PREPARED FOR THE PLAN COMMISSION

Project Address: 5535 University Avenue (District 19 – Ald. Furman)
Application Type: Demolition Permit and Conditional Use
Legistar File ID #: [53124](#)
Prepared By: Chris Wells, Planning Division
Report Includes Comments from other City Agencies, as noted
Reviewed By: Kevin Firchow, AICP, Principal Planner

Summary

Image 1: Section Looking Eastward

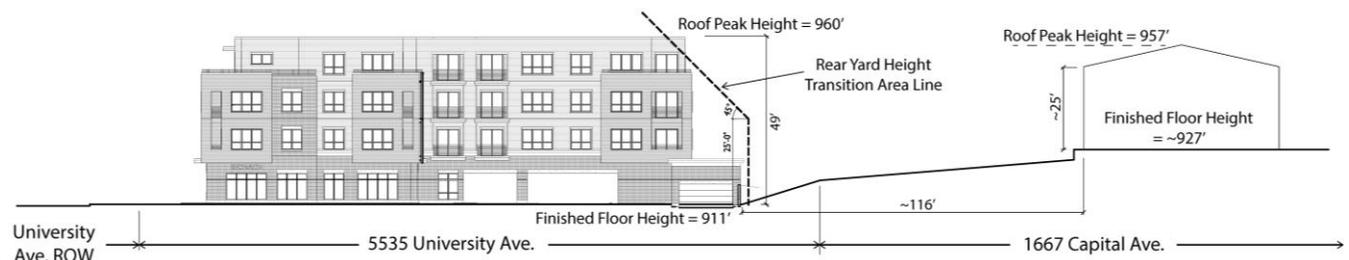
Looking at Image 1 below, one can see the upper right corner of the building (i.e. the southeasterly corner of the building’s fourth floor) extending into the transition area (which is indicated by the angled dashed line). (Note: this infringement has not changed from the previously approved plans). While such a restriction on height transitions is most applicable, and valuable, in infill situations when, for example, a multi-story building is proposed on a block of small and/or narrow lots, for the 5535 University Avenue case, Planning Staff anticipate that that this specific encroachment will not result in significantly different impacts than what would be allowed without the requested conditional use. This is due to the fact that the structures are not only approximately 116 feet away but due to the amount of grade change between properties, the level of the ground floor of the neighboring two-story residential building is roughly 16 feet above that of the subject building.
